HDI Thruhole Discussion with Yamashita co.

RIKEN/RBRC
Itaru Nakagawa

Hideto Enyo, Yasyuki Akiba, IN visited Yamashita co. on May 13th

Module-70 Thruhole

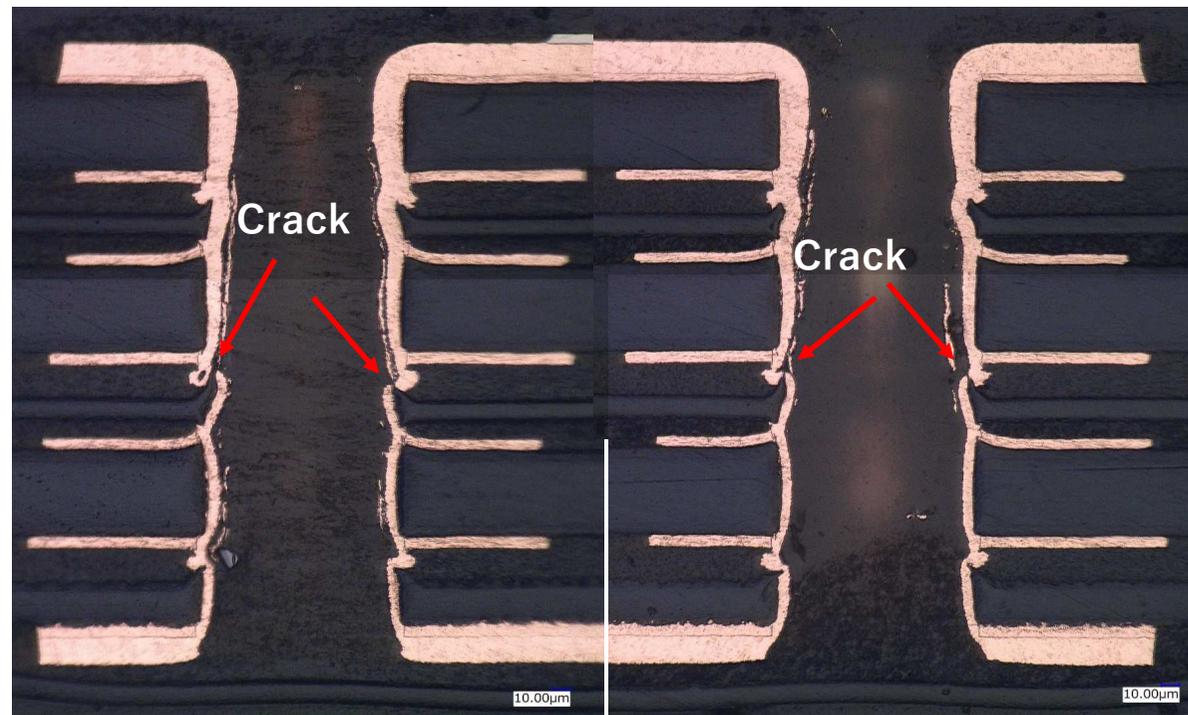
- The first HDI inspected thruhole XS
- Cracks in the middle
- Disabled this and next LOT.

Serial Number 50 Thruhole Inspection

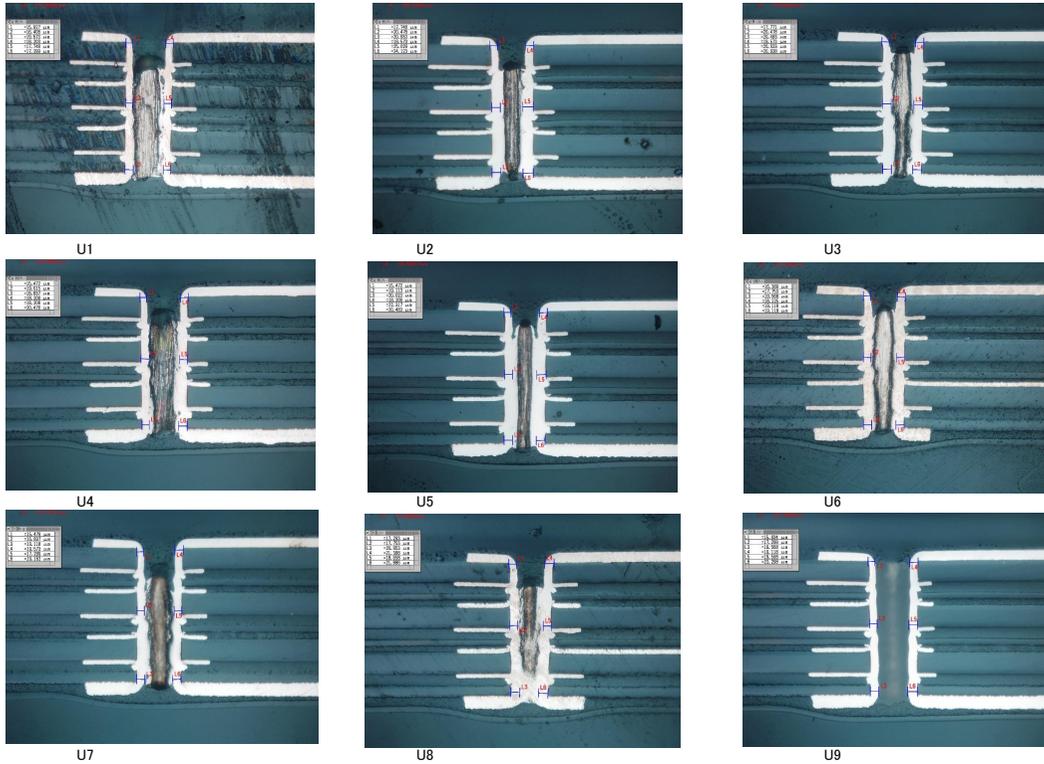
- Report from Yamashita on April 29, 2021.
- 1 thruhole per chip sampling XS inspection showed all OK.

All OK.

Serial Number 127 (LOT#311615)

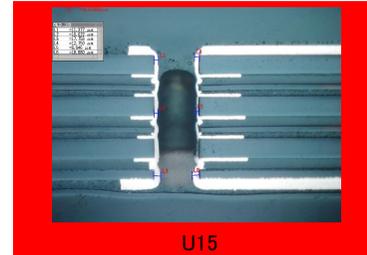
Found one bad thruhole

Module 265

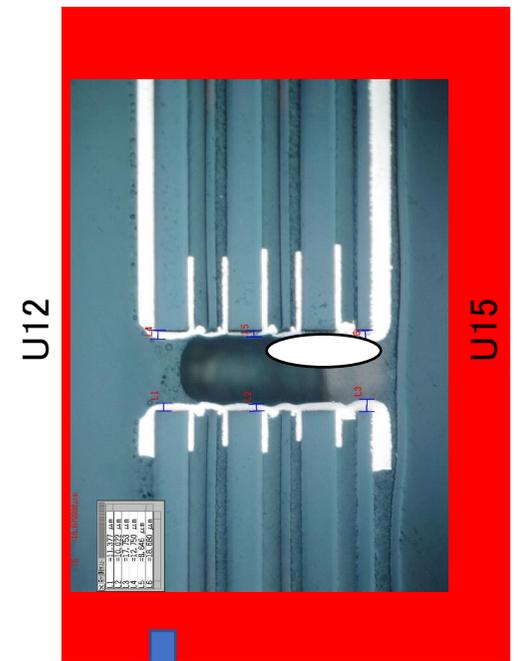
← Inspection good
